# Service Bulletin

ISSUE NO. M-045

**SUBJECT** MODIFICATION OF CRANKSHAFT

**APPLICABLE MODEL** GT750

### THRUST WASHER, CRANK PIN BEARING

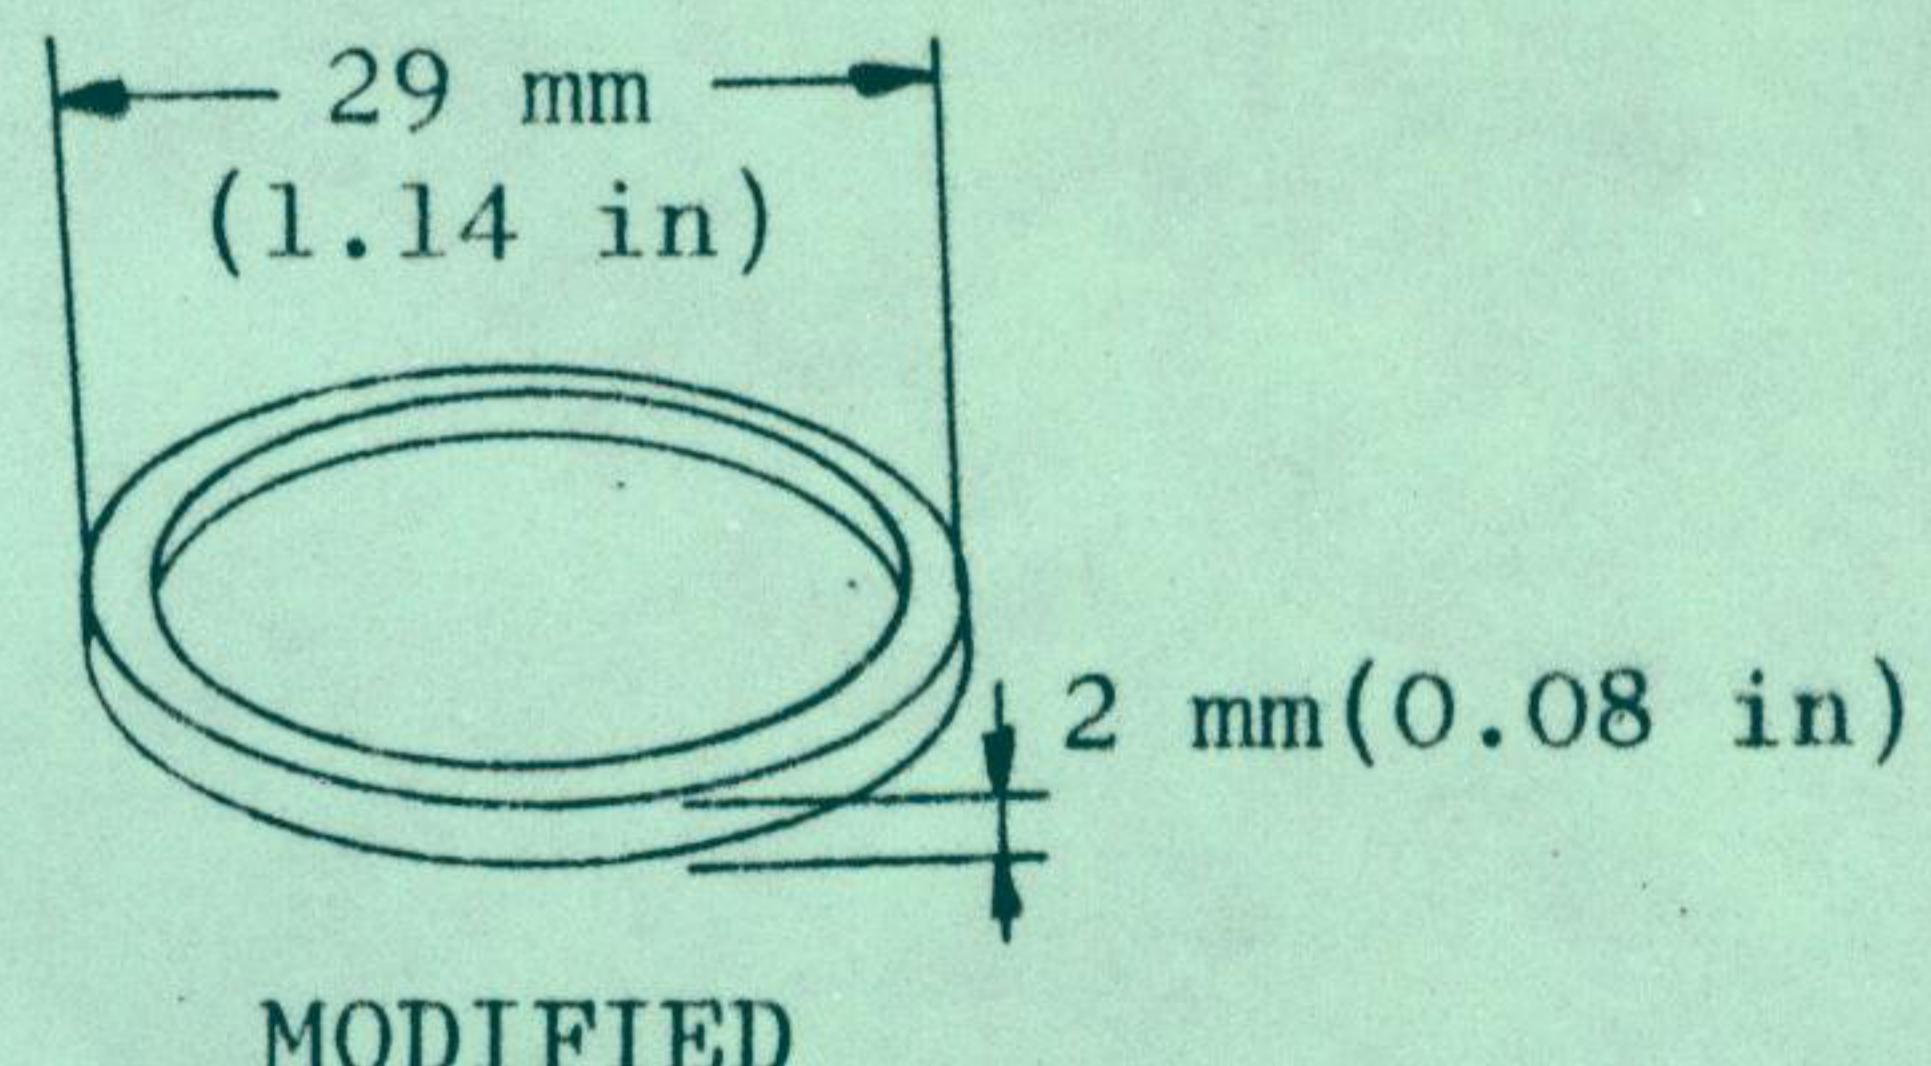
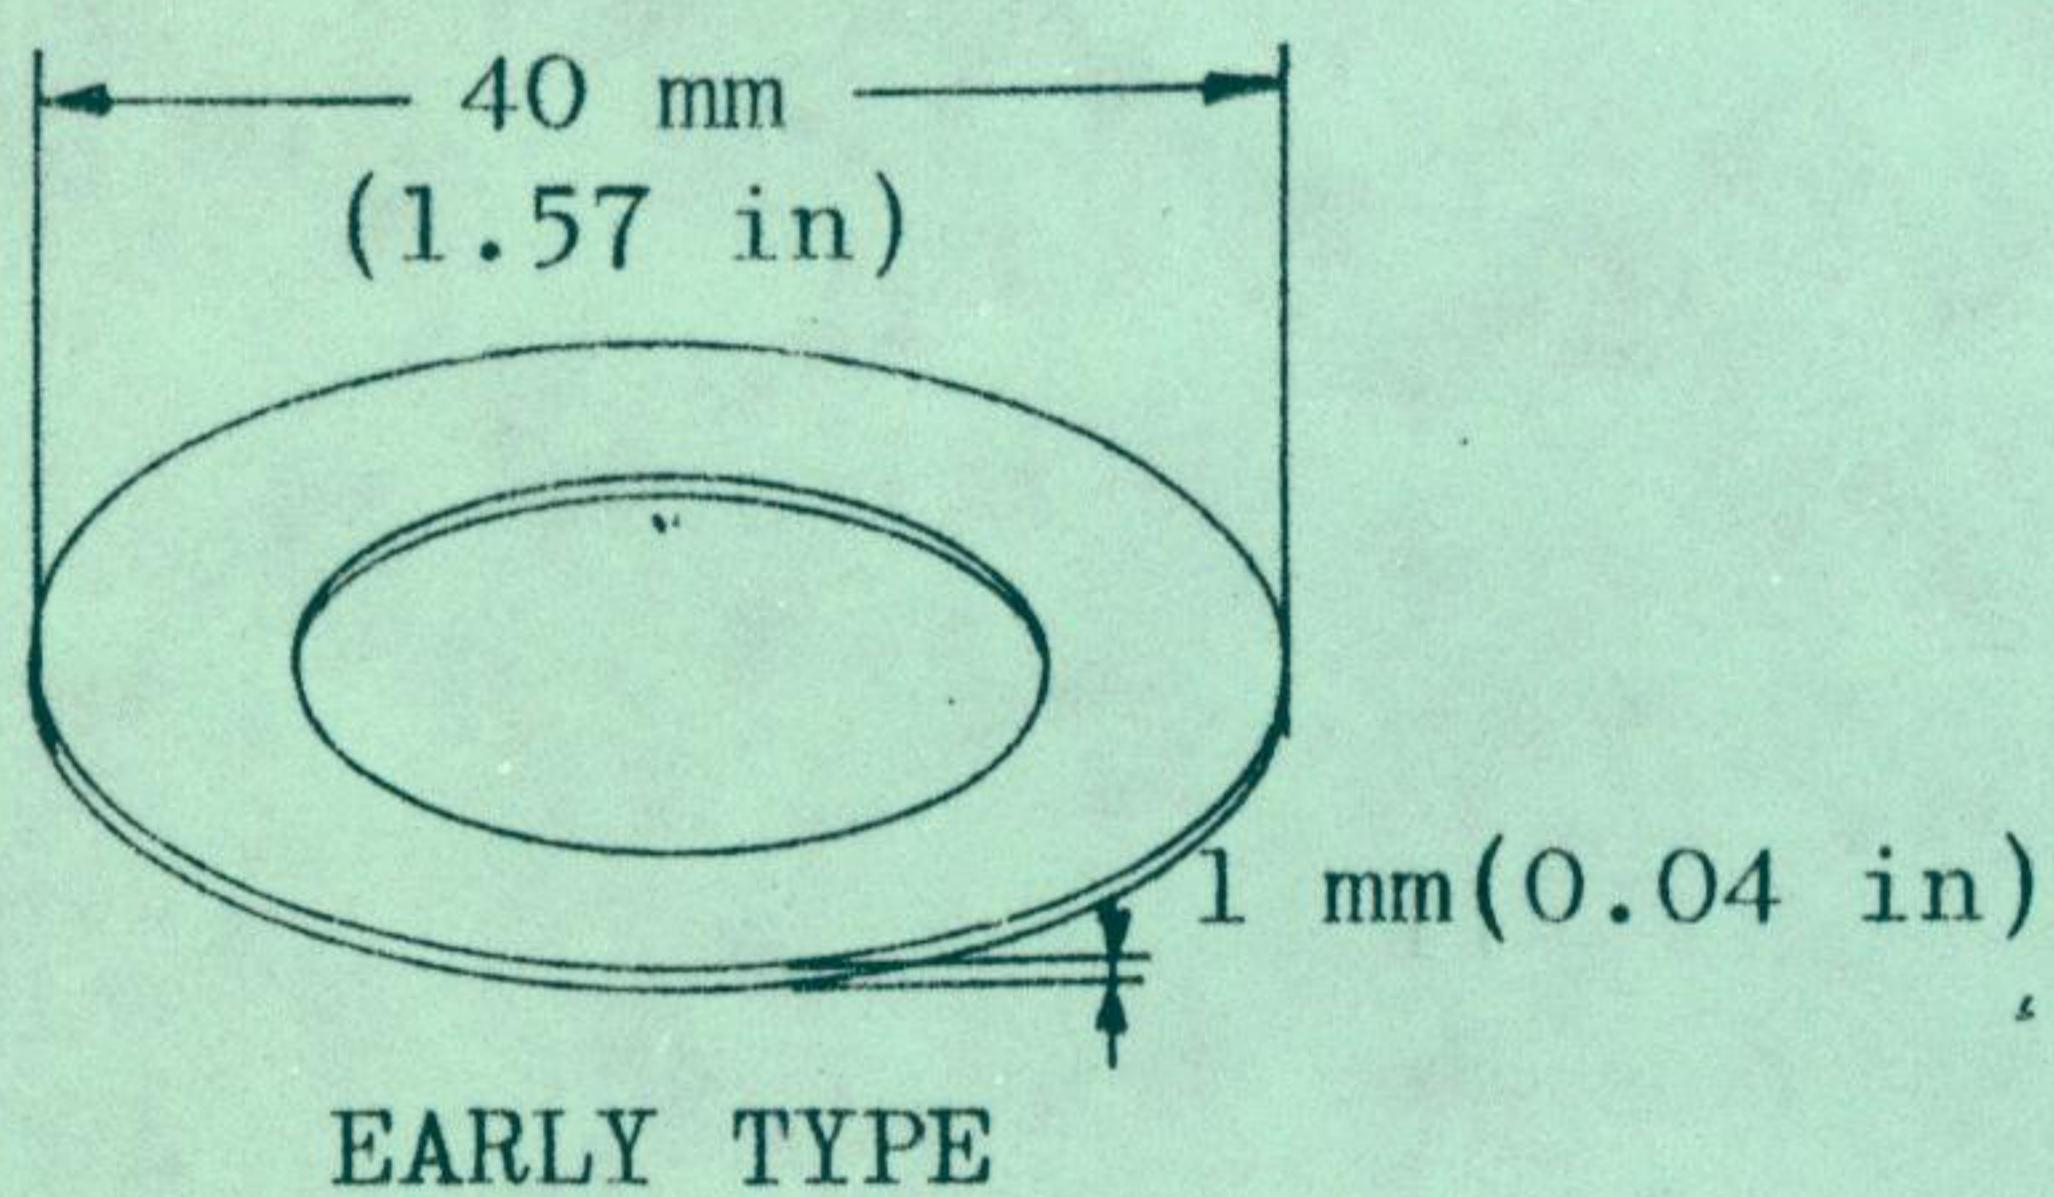
In order to have the con-rod floated, the thrust washer has been modified as shown below.

### CYLINDER GASKET

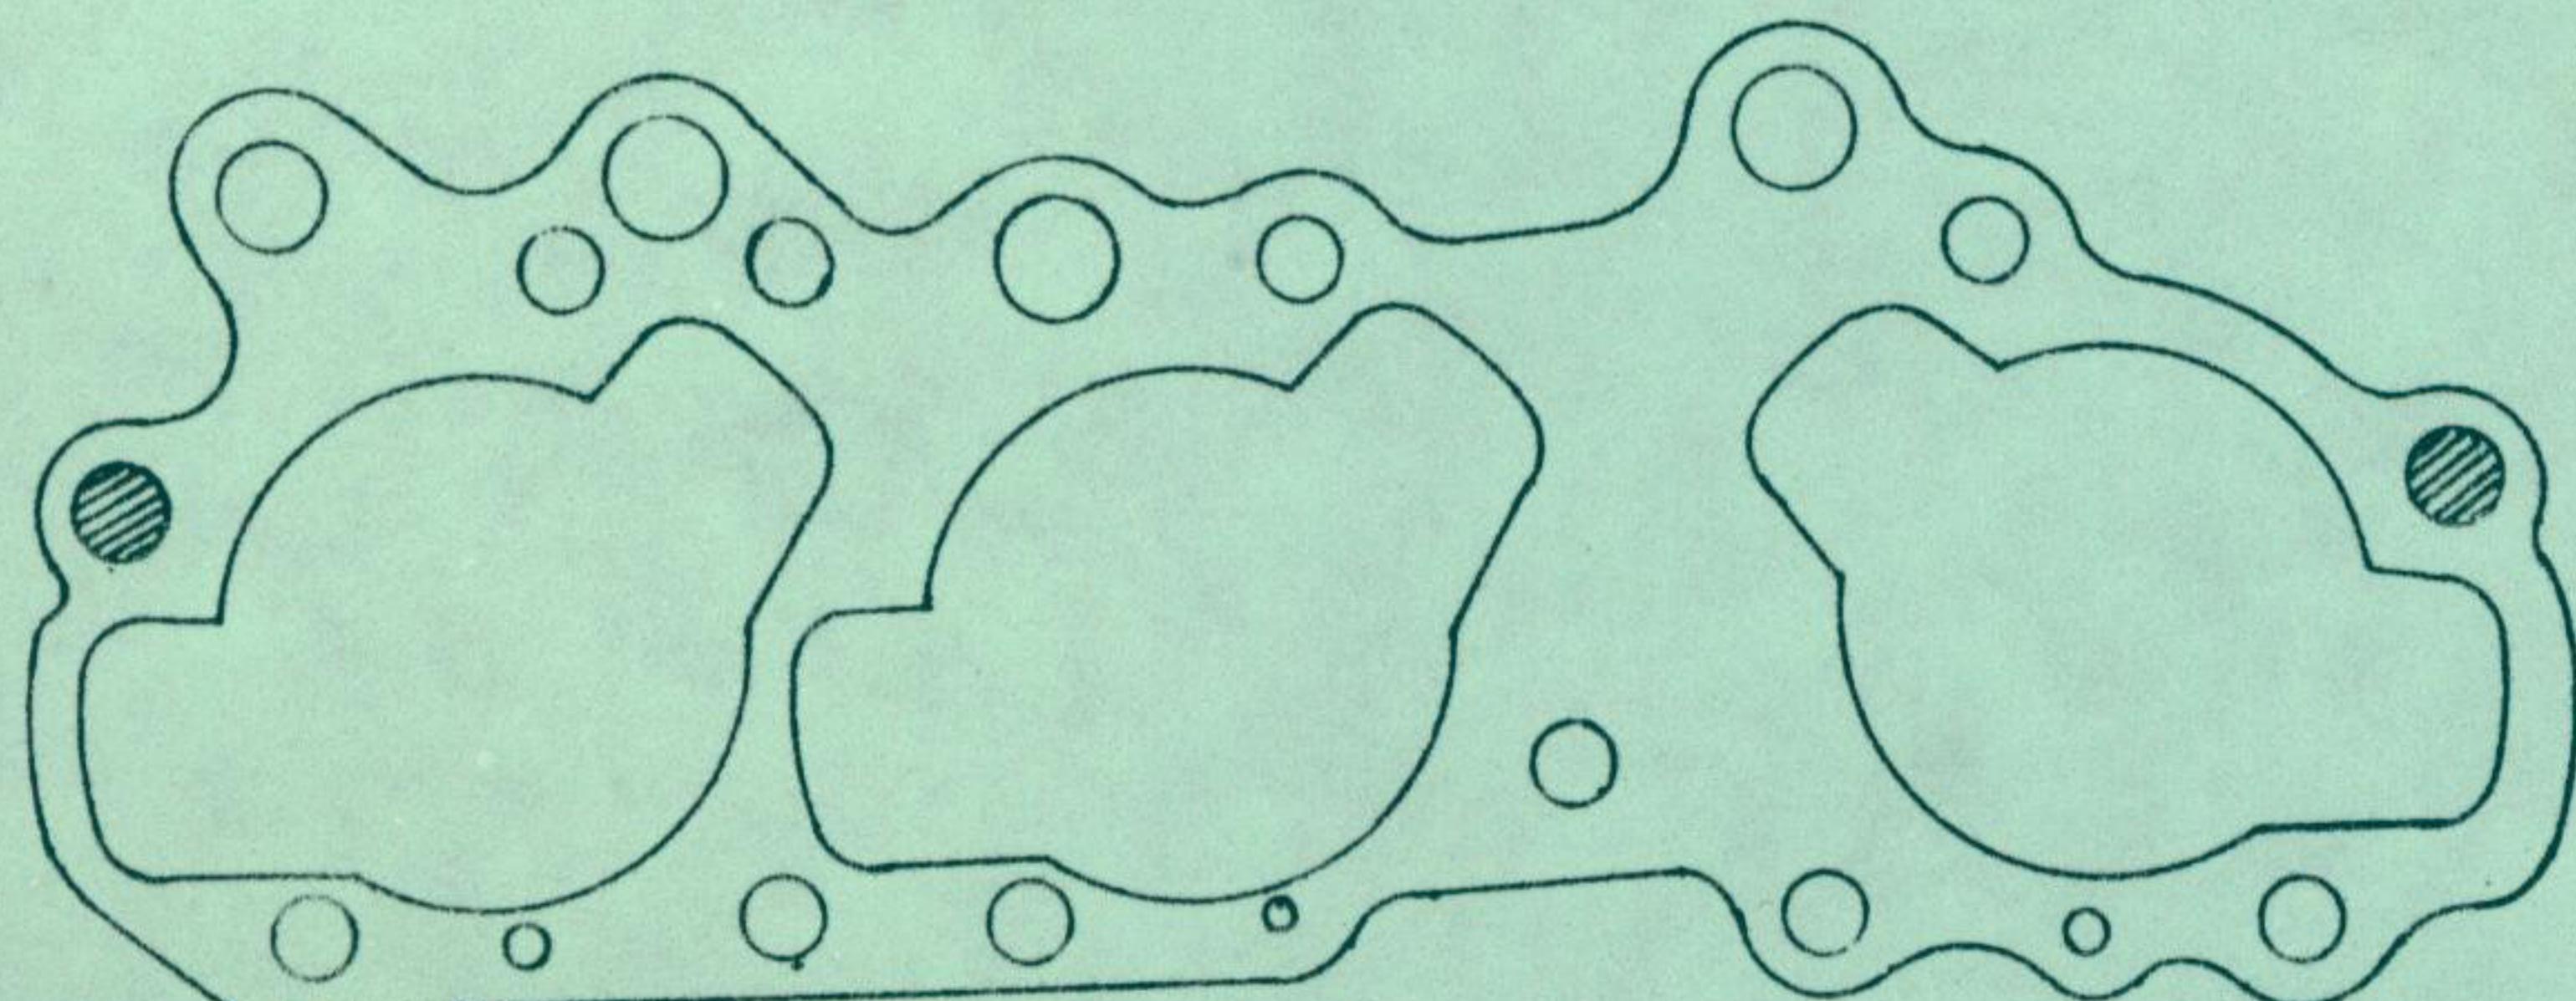
Two holes on the gasket are enlarged from 11mm (0.43 in) to 12.5mm (0.49 in) in the diameter so as to meet the size of the new stud bolt being thickened.

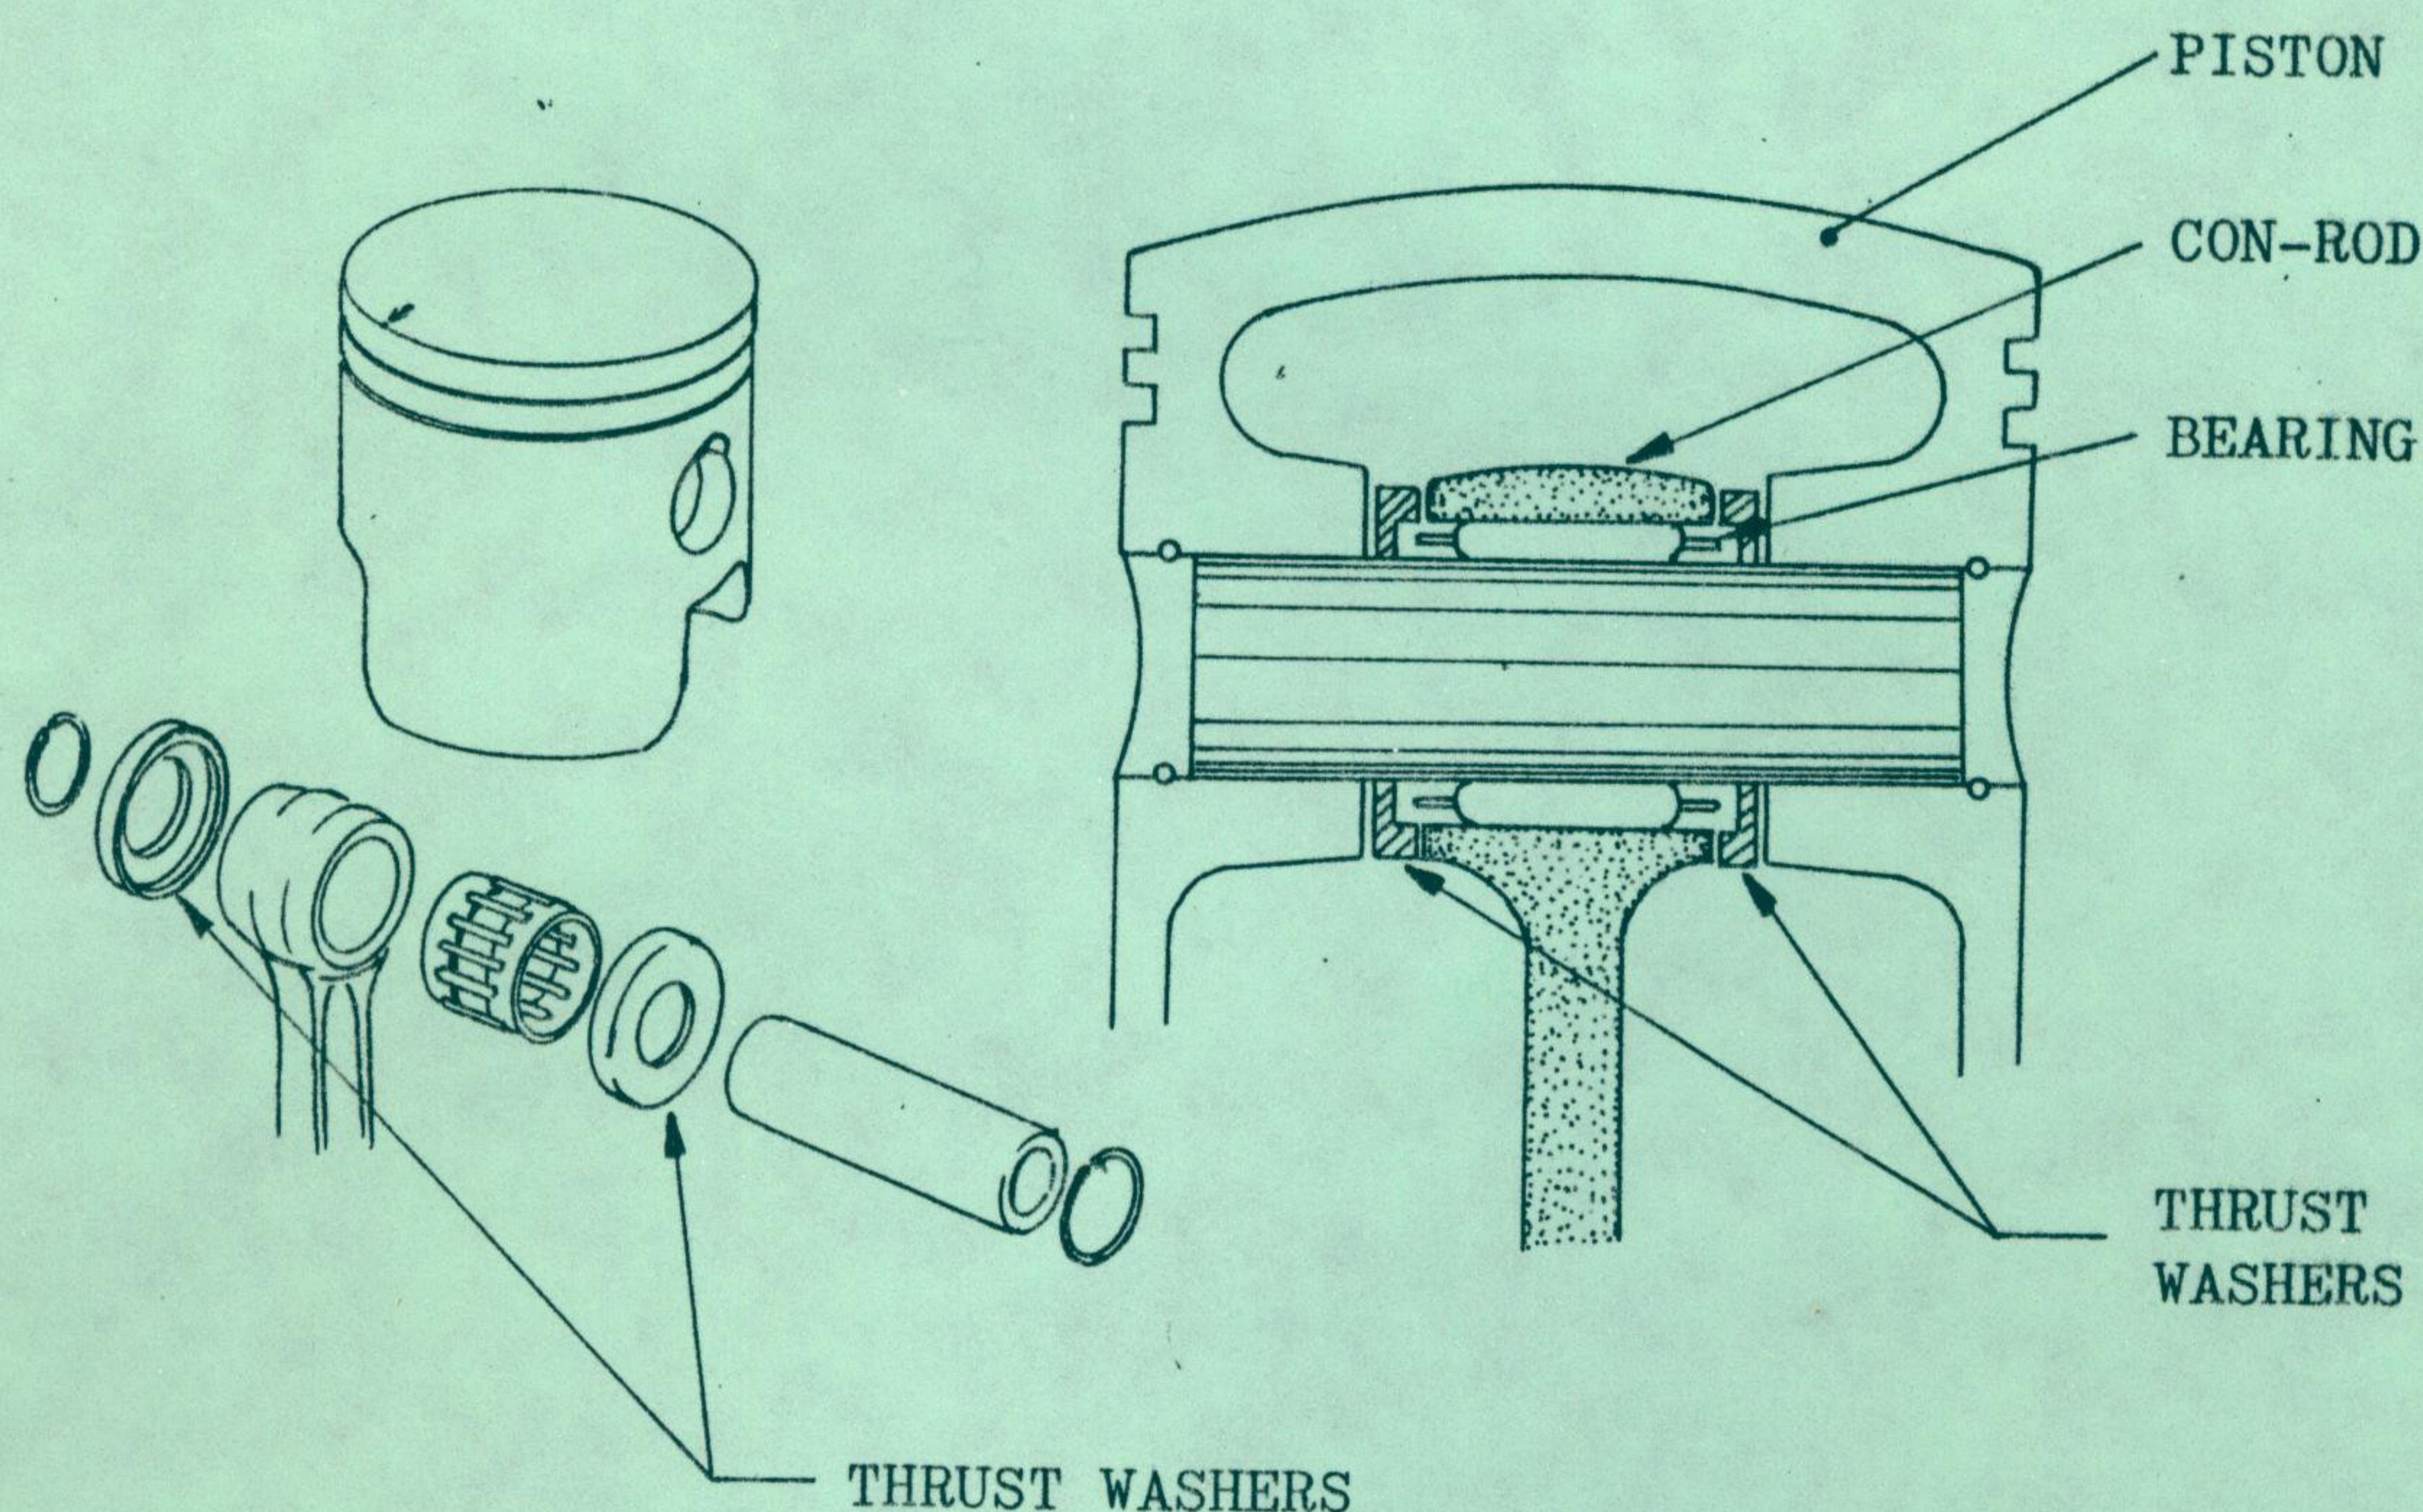
- 1) The piston and the thrust washer should be assembled as shown below.

NOTE: Two kinds of different pistons are used in the engine marked "R" and "L" on the head and the piston with "R" is for right and that with "L" is for left and center cylinders.
